**PLANNING COMMISSION
Regular Meeting
Monday, May 13, 2019
6:00 PM
Christine Nuernberg Hall**

Agenda

TO: Planning Commission
FROM: JAC ZADER, ASSISTANT DIRECTOR COMMUNITY DEVELOPMENT
DATE: May 13, 2019
SUBJECT: Stephen Perry Smith for Foxtown Venture. The applicant is seeking conditional use grant and building and site plan approval for two proposed buildings that exceed two stories in height as part of the Foxtown development for the property located at 11124 N. Industrial Drive.

REDUCE SIGN AREA

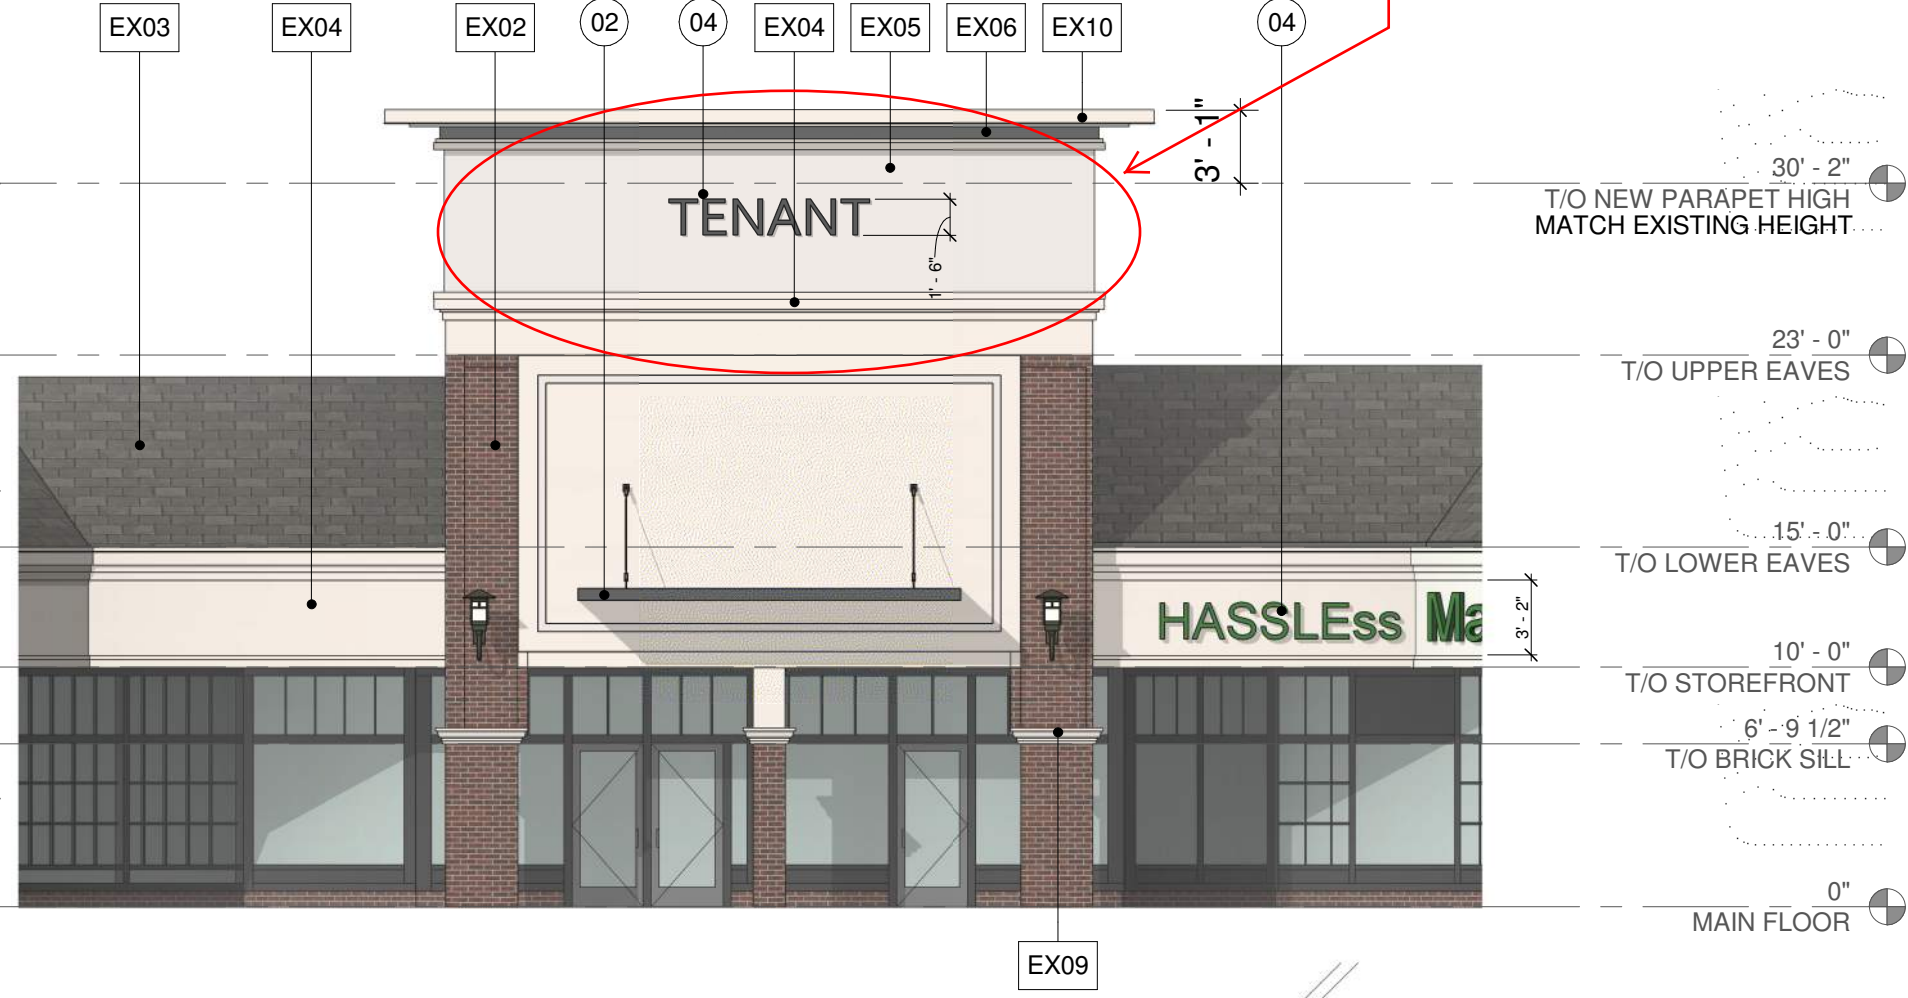
Reduce Wall Height
Reduce sign height

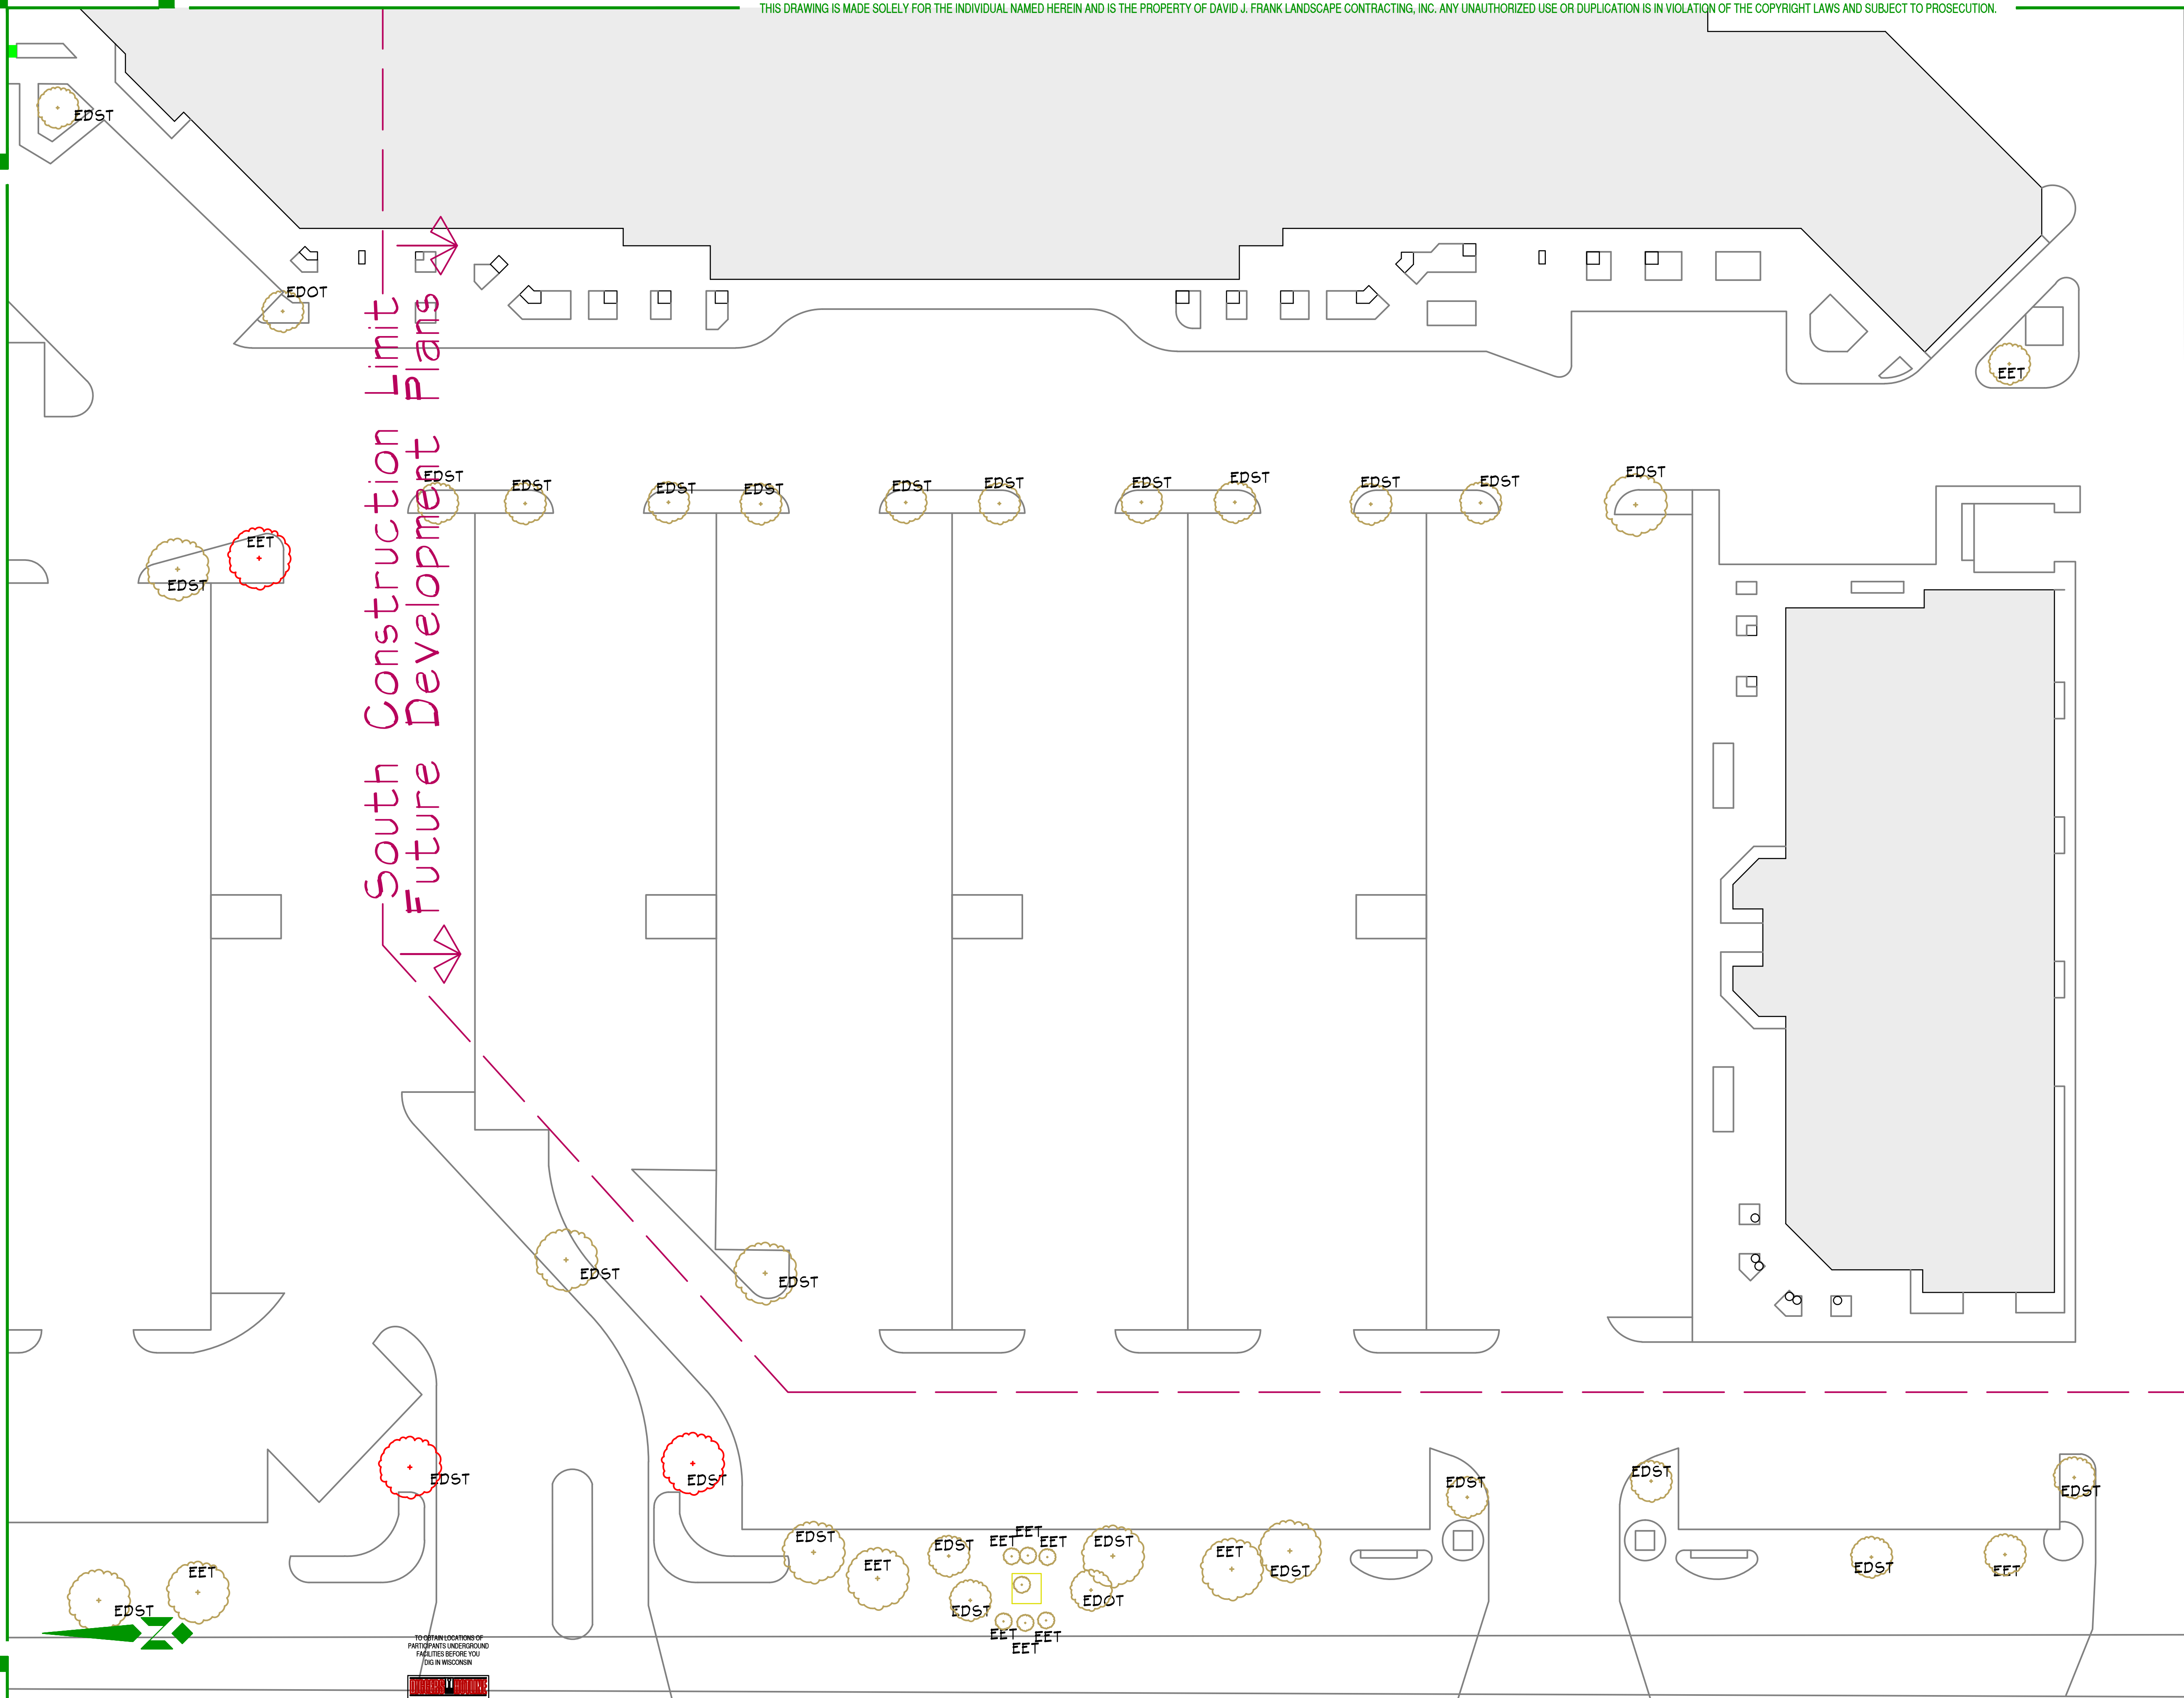
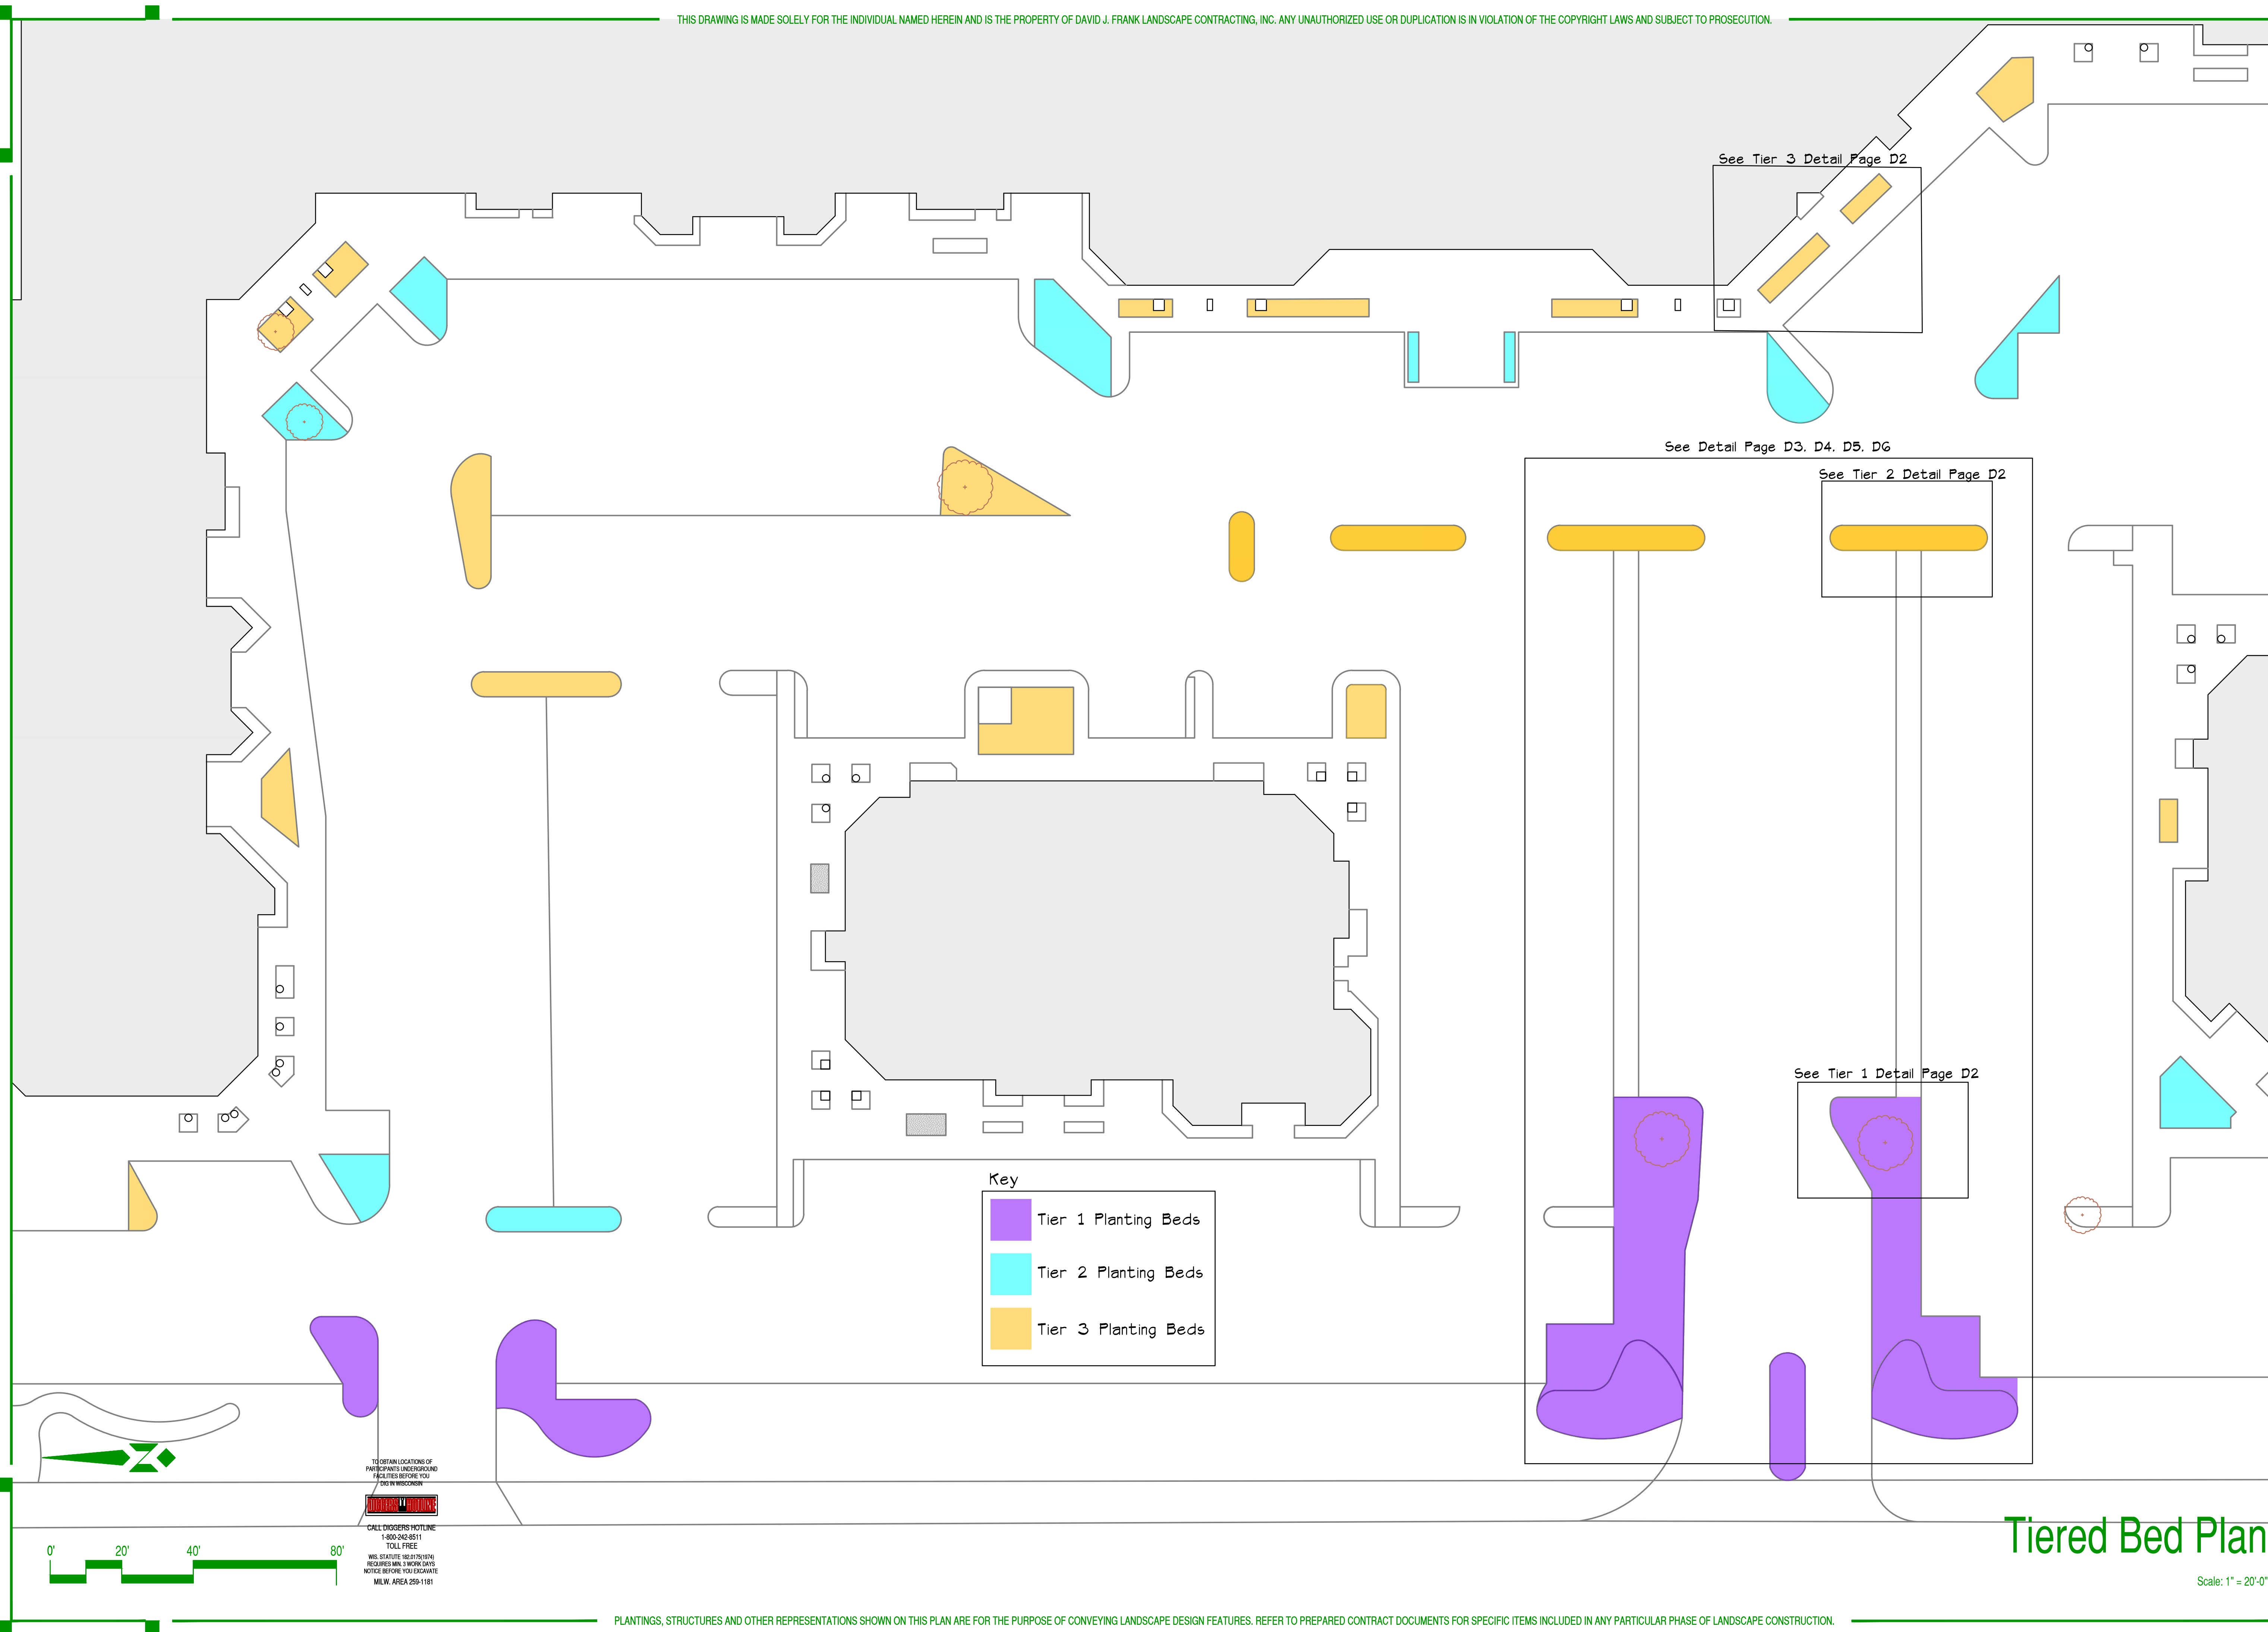
- ❖ The plan sheets S1 through S5 are drawn at a 1"= 60' scale; sheets B1 & B2 are drawn at 1"=30'; T1-T4 are drawn at 1"=20'; sheets P1-P3 are drawn at 1"=20' Sheets scale provides a single site plan sheet at a 1"=20' scale. The plan sheets are clean only because they contain little useful information. The plan set is not easily discernable because of the following reasons:

- The plan proposes multiple tree and island removals on Sheets S1-S3, yet the proposed removals continue to be graphically represented through the subsequent plan sheets. To compound the issue, “proposed planters” are also represented as existing on the Demo Sheets. Please amend these graphic anomalies so the Planning Board can understand the visual impact of removing the foundation & pedestrian walk planters.
